<u>User Department's Recommendation</u> : SUBJECT: ITB#18-100966- Fire Pumper, 1000 GPM with Fire and EMS Equipment			
Recommended Bidder:Williams Fire Apparatus meets our approval.			
Amount Spent on Previous Contract: N/A			
Funding: Vehicle Replacement Fund General			
Disbarment and Suspension checks completed-Yes			
Project Amount This Term: \$678,222.00 x5 = \$3,391,110.00			
Justification: It is recommended that Williams Fire Apparatus, Inc., who represents Sutphen Corporation, is the responsive bidder and provided a bid that exactly met the requirements of the specification.			
FireLine Inc. was the lowest bidder; however, the vendor did not propose a fire apparatus that resembled the DeKalb County specification. Below is a table showing the various inconsistencies between the FireLine proposal and the DeKalb County specification. Also below is inserted the proposal drawings from FireLine Inc. and Williams Fire Apparatus. You can see the visible differences in interpretation of the DeKalb County specifications in the drawings. The other bidders were higher in cost and therefore not acceptable.

Below is the proposal drawing from FireLine Inc.

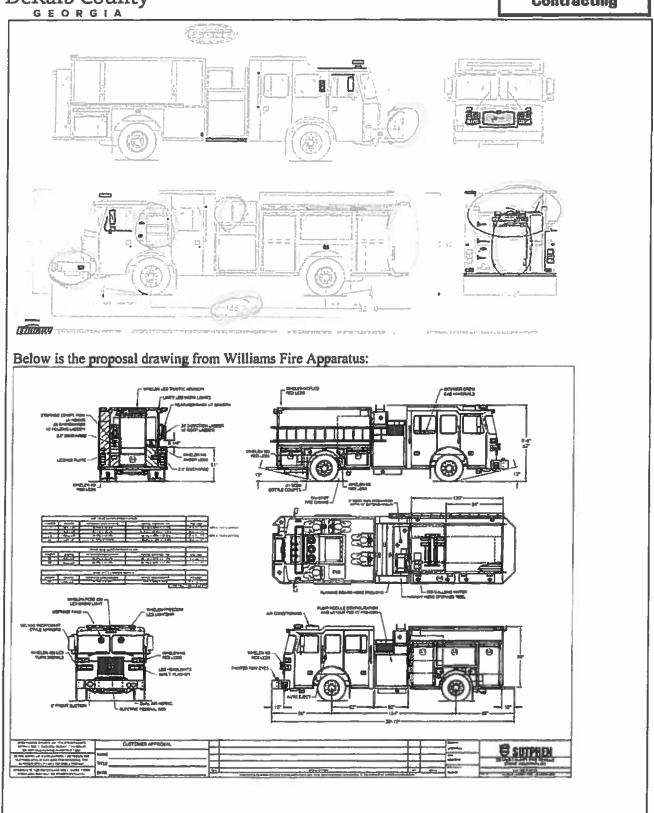
36. Rear Body Compartment – Drawing shows a full height rear compartment causing a high hose bed. Not acceptable.	36. With a low hose bed this compartment should show on a drawing approximately 26"Wx26"Dx12"H.
